Re: Caterpillar Clubhouse Daycare
803 2nd St. SW
30-Day Temporary Certificate of Occupancy
Transportation Development Final Inspection
Architect's Stamp dated 04-11-22 (K14-D227)
Certification dated 09-06-23

RE: Traffic Certification Letter for Caterpillar Clubhouse Daycare

DATE 5.6.22
PROJECT NO. -
TRAFFIC CIRCULATION LAYOUT
SHEET NO.
TCL-1

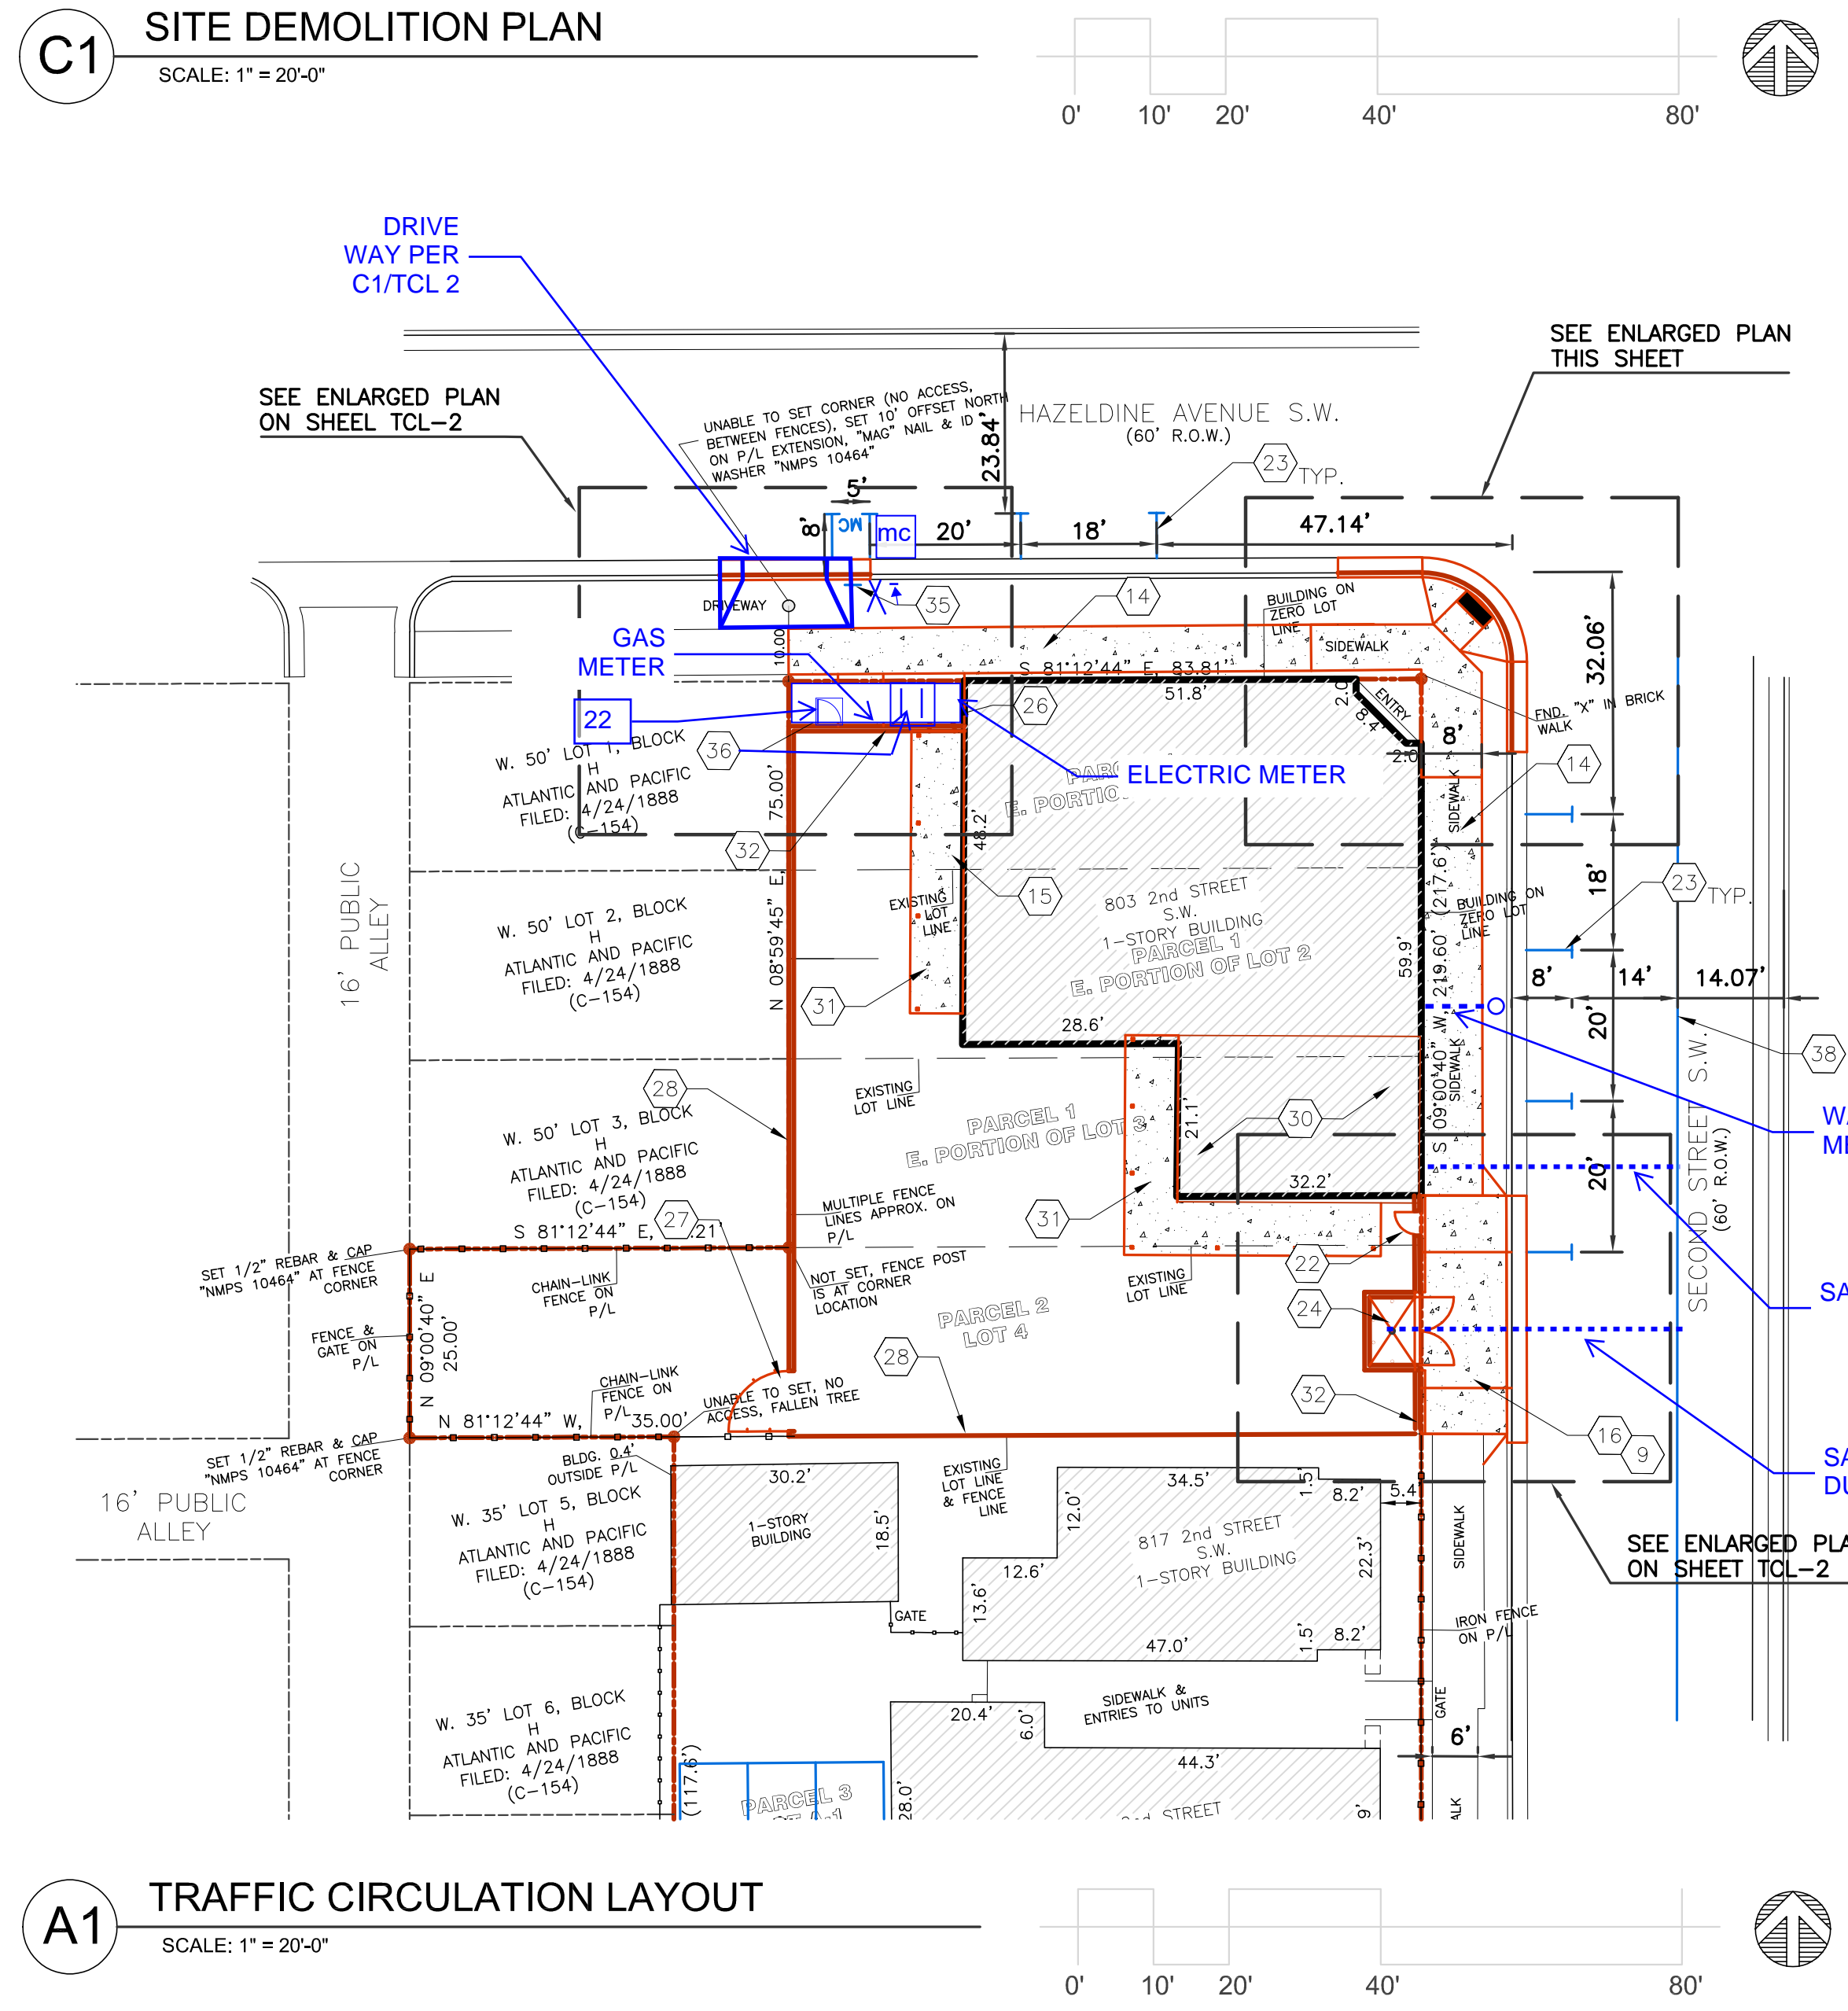
- Per approved TCL letter, please provide the Shared Parking agreement.
- Please finish the construction of the walkway path, the Personnel Gate must be installed.
